APPROVED MINUTES OF THE MEETING

June 4, 2009

June 4, 2009	Project:	Madison Valley Storm Water Improvements – Phase II
	Phase:	Concept Design
	Last Reviewed:	March 19, 2009
	Presenters:	Tom Finnegan, MWH Brent Middleswart, SPU Gail Staeger, Nakano Associates Mark Graham, MWH Kenichi Nakano Nakano Associates Grace Manzano, SPU

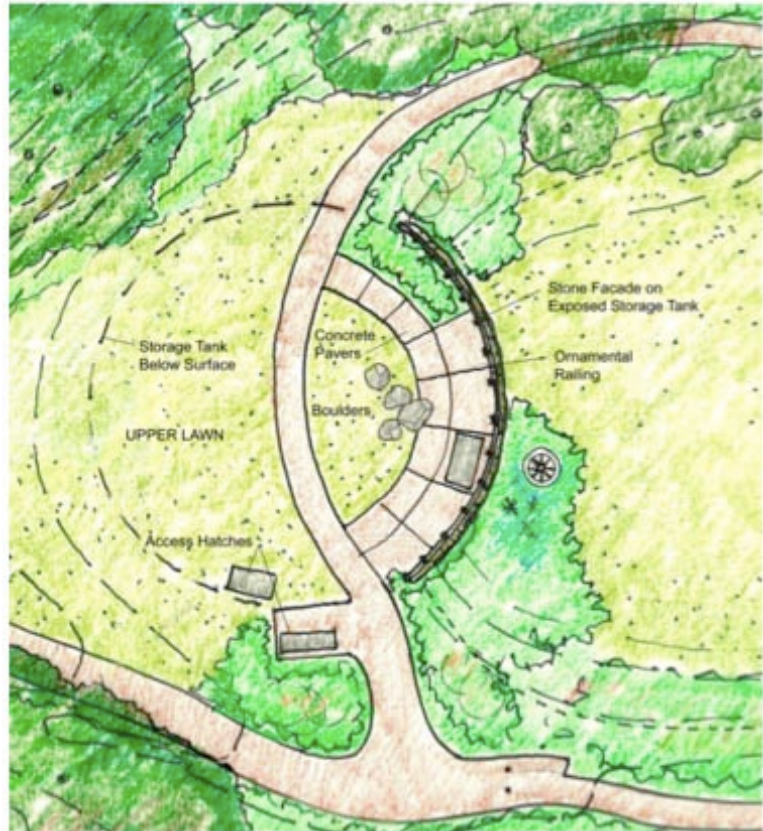
One way that you could get in the idea of the power of water and the retention of it is to take the path around the outside of the tank to create a more powerful image of the size and scope of the tank.

The service road and the parking spaces need to be integrated better, particularly between the two materials for the pathways.

In terms of plantings, I'm excited about the types of planting you are proposing, but when I look at the site plan and the dark green and light green I'm wondering the logic of where you are locating your plantings. I'm feeling that the path orientation and the open spaces you are creating could be more intentional and graceful.

It seems the primary element, the tank, is fighting between being expressed and being hidden. The theme of the tank could be utilized in the pathway design as well by creating circular nodes at various points.
